**Bid Addendum One**

Project: **Tullip New Utilities Building**  
Project No. Tulalip Tribes Project No. 2021-003

Date of Issuance: April 16, 2024

Issued By:  
Freiheit Architecture

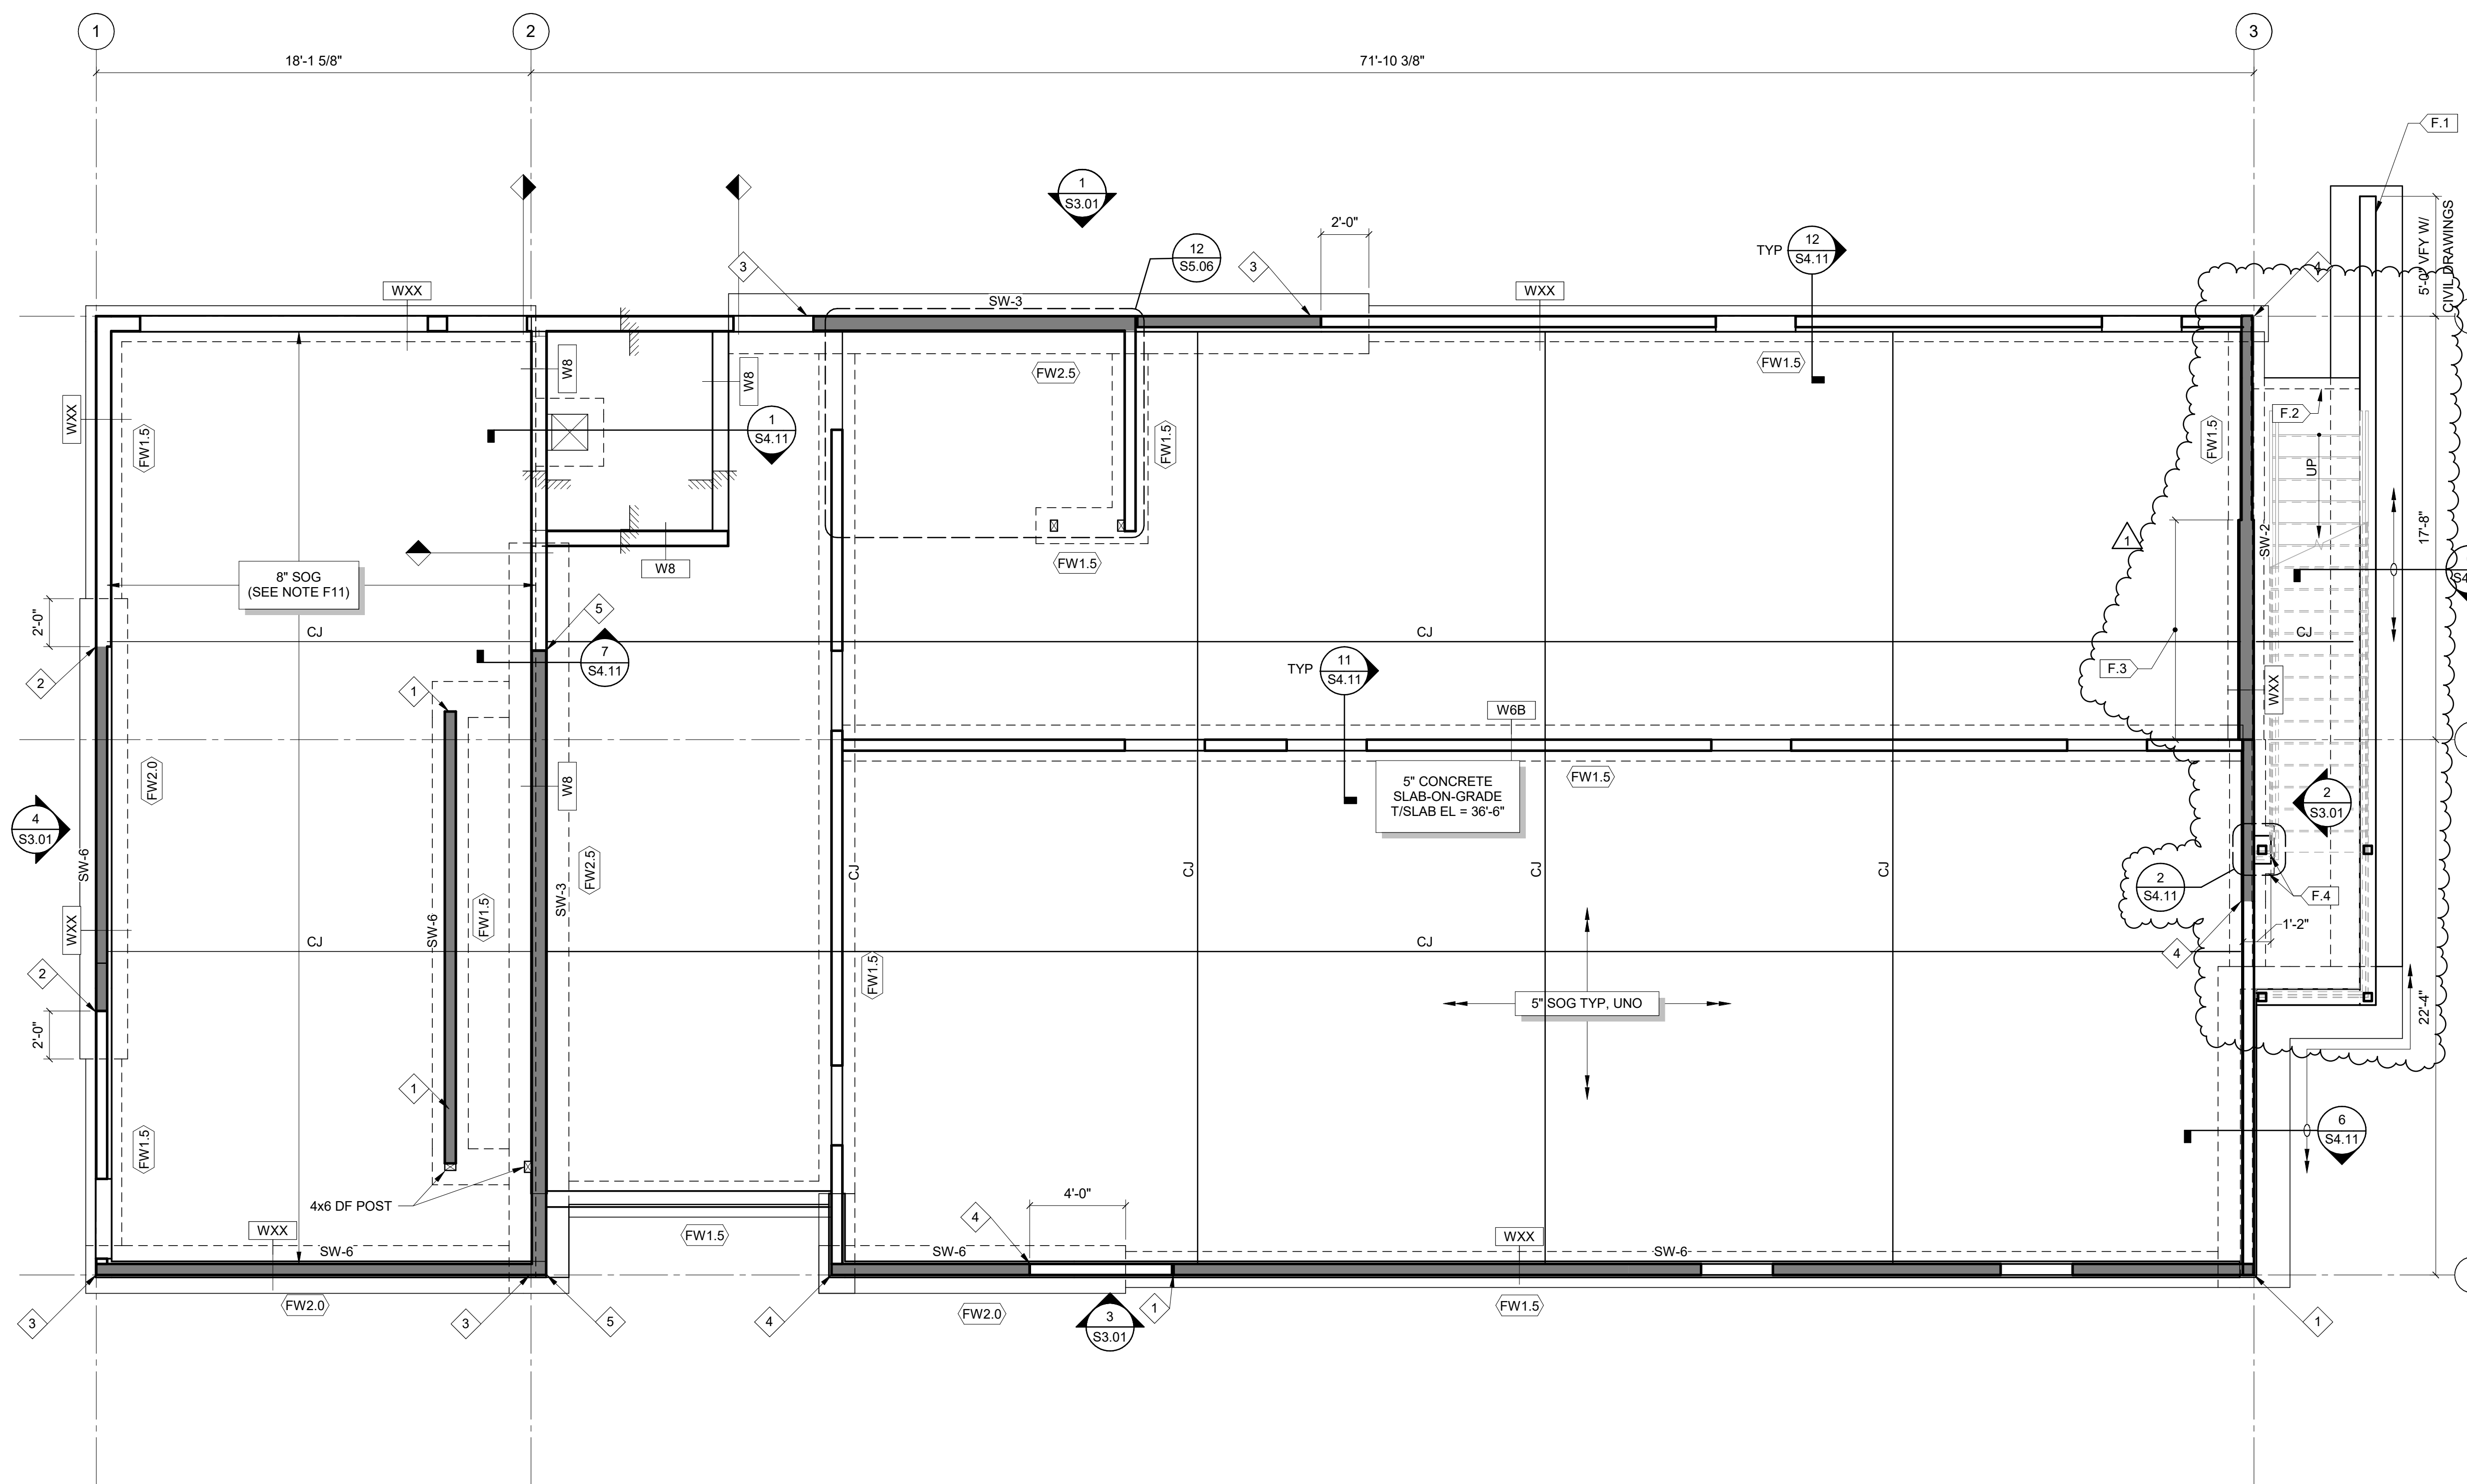
3. S2.01 Foundation Plan Does not show a footing or thickened slab under the portion of Exterior wall that runs from Gridline A to approximately Gridline B.5 on Gridline 3. There is a Hold-down Number 4 that indicates a 9" embedment. Please provide a section at this exterior wall. (see attached)

- 3. ***See Bid Addendum 1 drawings dated 4/16/24 for footing under Grid 3 exterior wall. Locally increase 10" footing depth to 1'-0" at holddown to provide 3" minimum cover.***

Sheet	Summary of Revisions
S2.01	<ul style="list-style-type: none"><li>• Replaced wood-framed east stair with pre-engineered steel stair.</li><li>• Added corbel under stair post.</li><li>• Clarified stem wall thickness at 8" studs.</li><li>• Showed missing wall footing at Grid 3.</li></ul>
S2.02	<ul style="list-style-type: none"><li>• Replaced wood-framed east stair with pre-engineered steel stair.</li><li>• Added strapping at north edge of stair landing.</li></ul>
S2.03	<ul style="list-style-type: none"><li>• Added new east stair landing roof below.</li></ul>
S3.01	<ul style="list-style-type: none"><li>• Modified Elevation 2/S3.01 to show new pre-engineered steel stair.</li></ul>
S3.02	<ul style="list-style-type: none"><li>• Voided wood-framed stair details.</li><li>• Added blocking at Section 6/S3.02 to receive new pre-engineered steel stair.</li></ul>
S4.11	<ul style="list-style-type: none"><li>• Deleted wood stair framing at Section 6/S4.11.</li><li>• Clarified stem wall thickness at Section 12/S4.11.</li><li>• Added new stair corbel Detail 2/S4.11.</li></ul>

**FIRST FLOOR PLAN**  
SCALE: 1/4" = 1'-0" 1  
E3.0

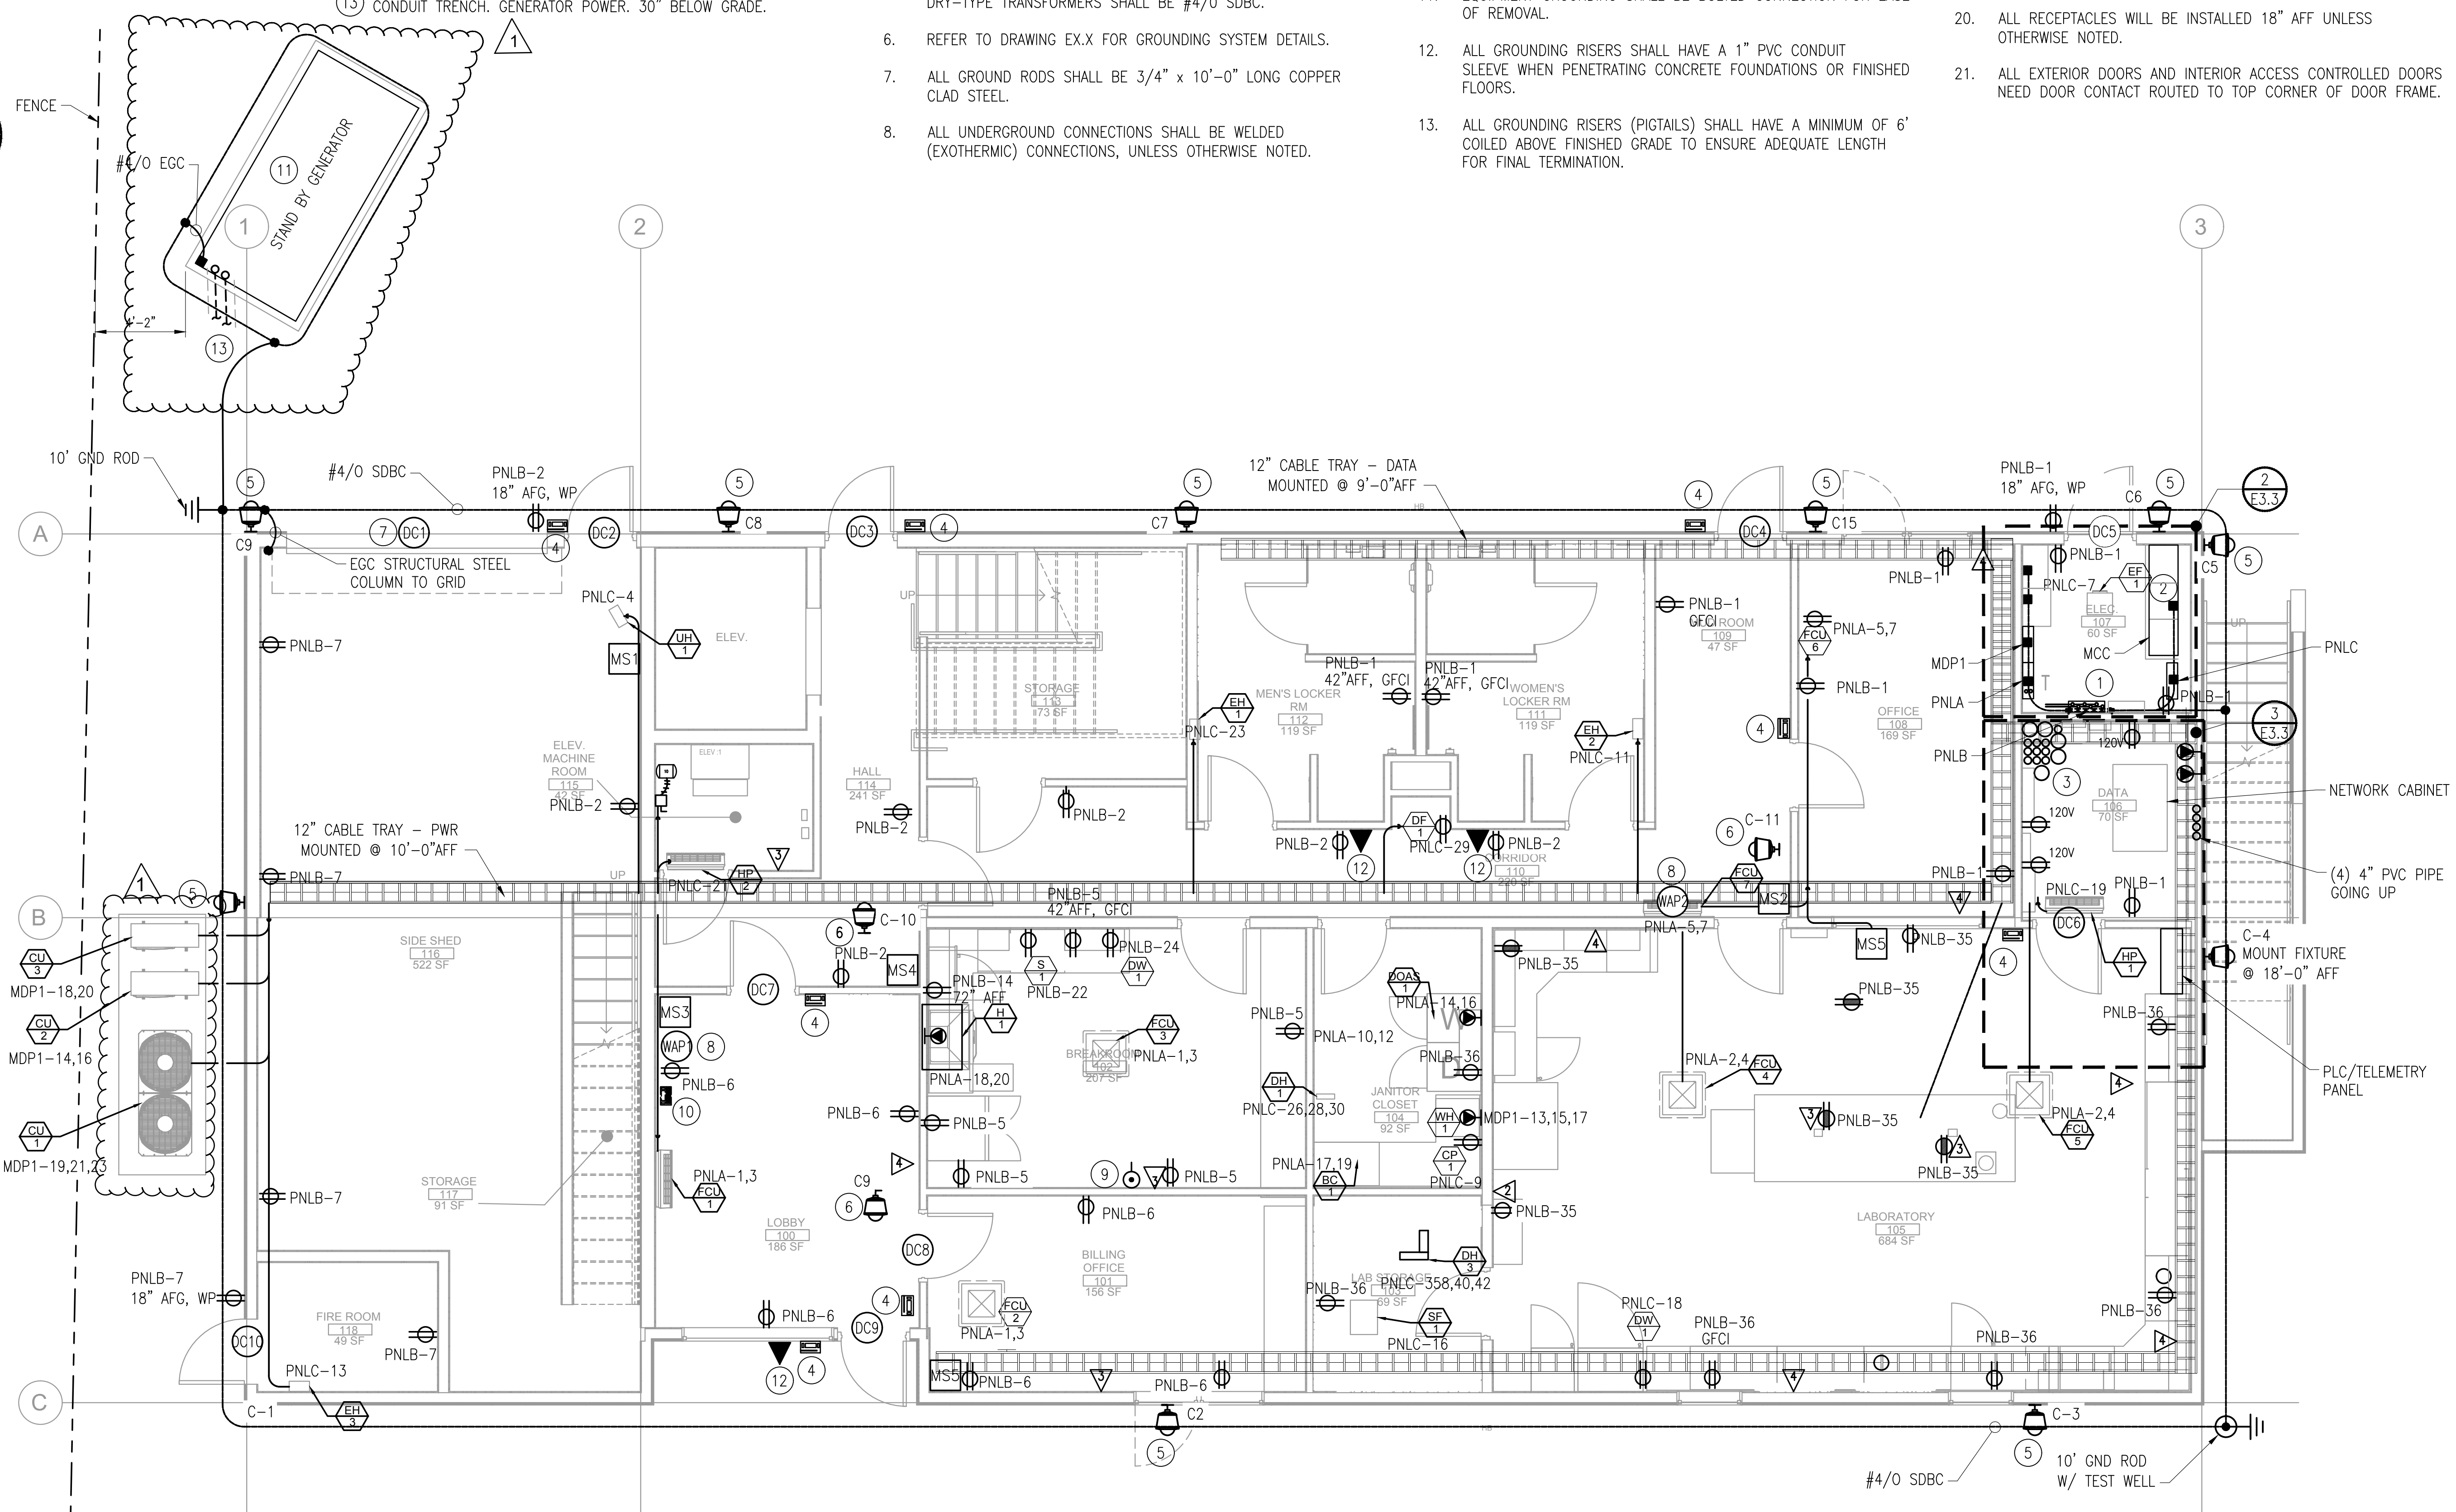
2. Please coordinate location of the generator pad between Sheet E3.0 and Civil/Arch plans. Any differentiation in distance between pad and the building will impact the cost of feeder.

16. Please confirm that underground power and data conduit is direct bury (i.e. no concrete ductbank required).
17. Please coordinate power feed run to generator between civil and electrical plans. It would appear that it makes sense to run power from electrical room through the building as much as possible in lieu of trenching through parking lot but confirm.

17. Please see revised electrical site layout E3.0 in Addendum Drawings.
18. Note that integration scope is assigned to TSI – contact Mitch Stewart.  
[mitchs@tsicontrols.com](mailto:mitchs@tsicontrols.com) cell 425-320-7632
